Responses to NRC Request for Additional Information

License Renewal Amendment Request

Source Material License SUA-1534

Subject: Response to letter received January 20, 2009 (Dated January 16, 2009) – Request for Additional Information, License Renewal Amendment Request, Crow Butte Resources, Inc., Crawford, Nebraska, License SUA-1534 (TAC J00555)

Figure 2.5-1. Comparison of Chadron and Crawford Temperature for Spring and Summer 1999

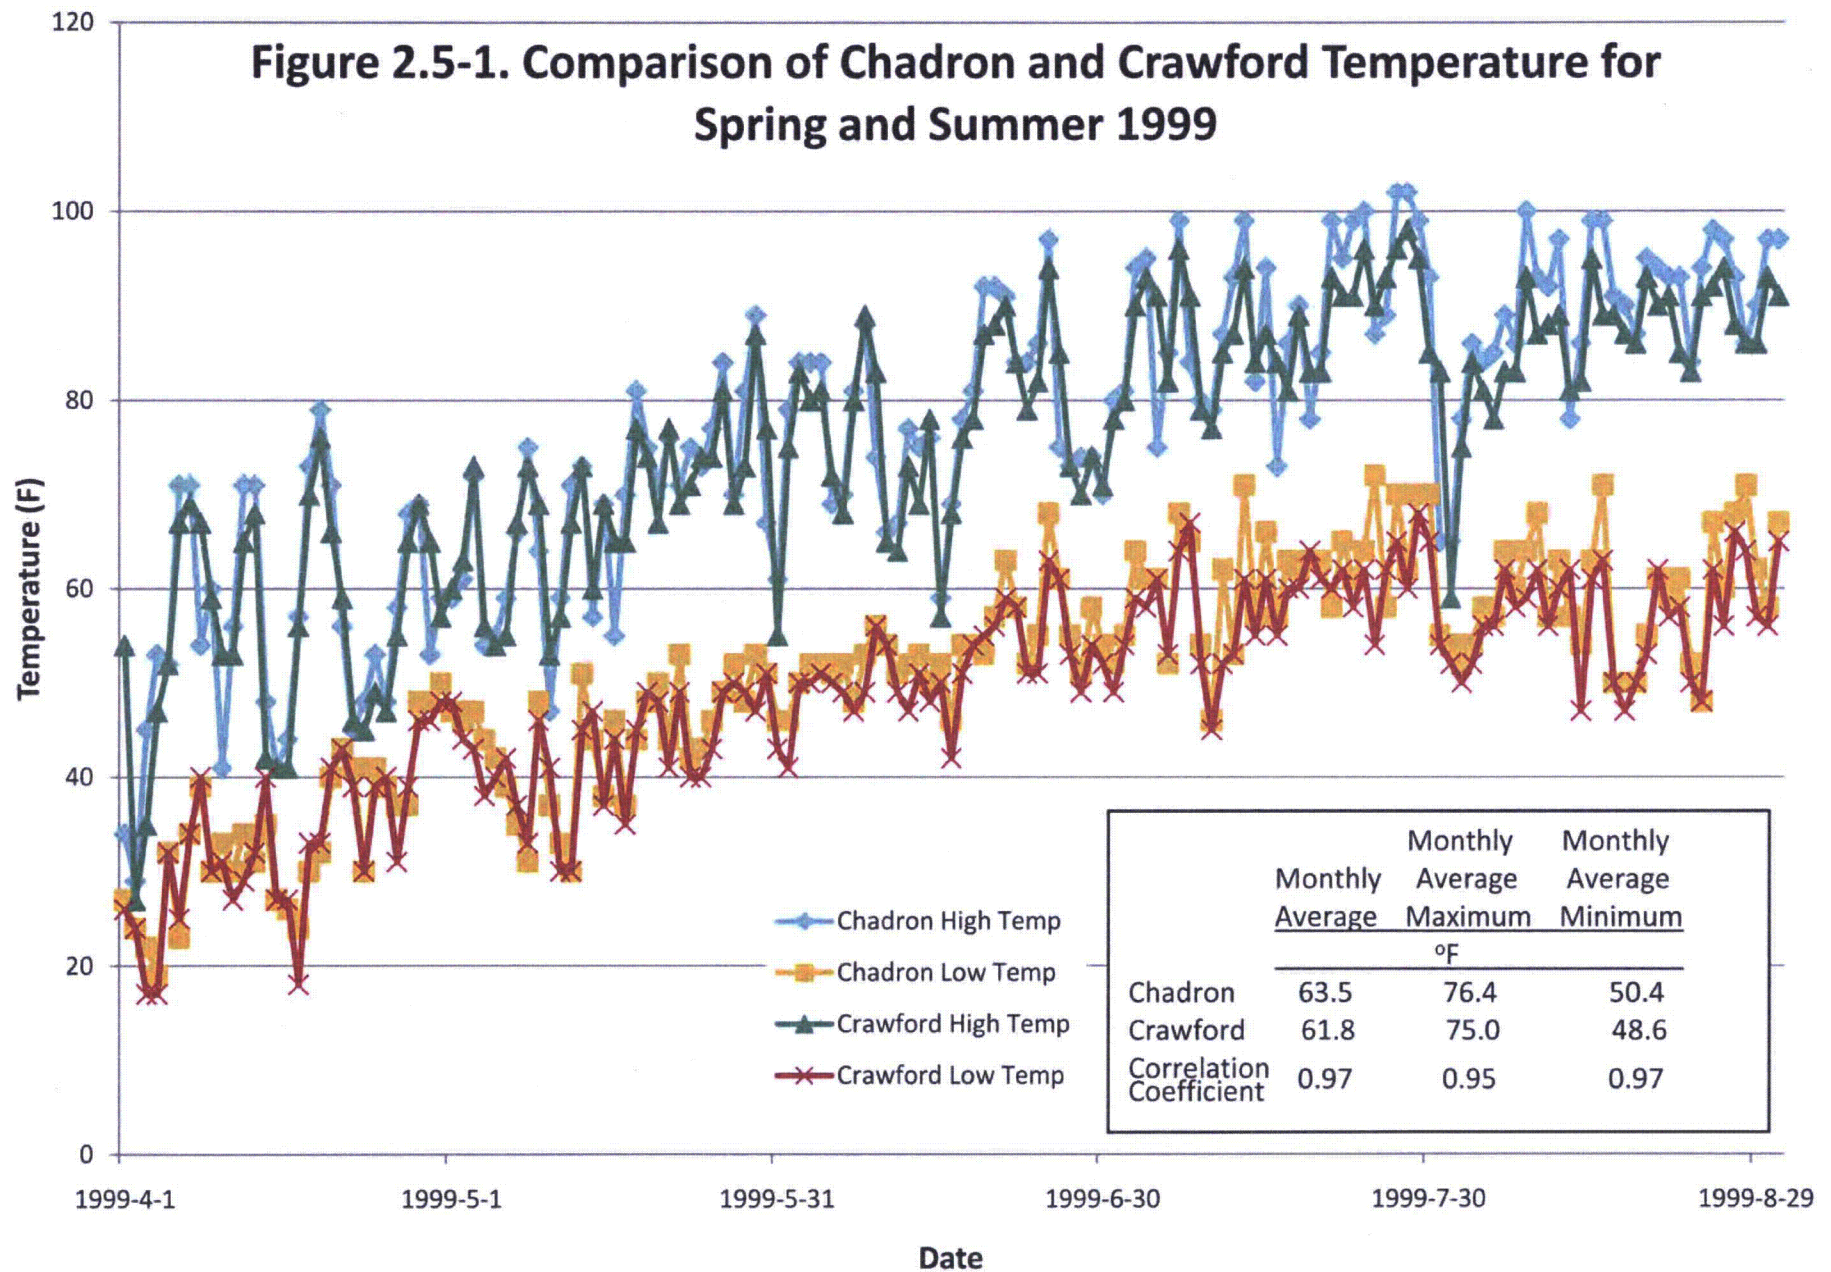
- 1. Please confirm that precipitation and temperature data from Chadron, Nebraska, are comparable to Crawford, Nebraska. NRC staff notes that spring and summer rain showers often occur as scattered thunderstorm cells; therefore, precipitation at one location may not be representative of another.**

A comparison of high and low temperature data for both locations indicate that data trends are comparable. In order to demonstrate this trend, comparisons were made of the high and low temperature data for Chadron and Crawford (Figure 2.5-1 of application). The relationship between these data for Chadron and Crawford is shown by calculating correlation coefficients: 0.95 for the monthly average maximum and 0.97 for the monthly average minimum. A perfect fit of the data gives a correlation coefficient of 1.0 and if there is no relationship, then the coefficient is 0.

Temperature data for the years 2004, 2005 and 2008 had an insufficient number of days without data measurements to make these results unrepresentative for the annual measurement periods; therefore, these data were not used. The temperature in Chadron, Nebraska is comparable to the temperature in Crawford, Nebraska. To demonstrate this trend, high and low temperature data for both locations for April through August 1999 are displayed in **Figure 2.5-1**. The source for Chadron and Crawford temperature data is Weather Underground (WUG 2009) and the National Climatic Data Center (NCDC 2009) operated by National Oceanic and Atmospheric Administration (NOAA), respectively. **Figure 2.5-1** shows the Comparison of Chadron and Crawford Temperatures for Spring and Summer 1999, and shows that the temperature data from the two weather stations are consistent.
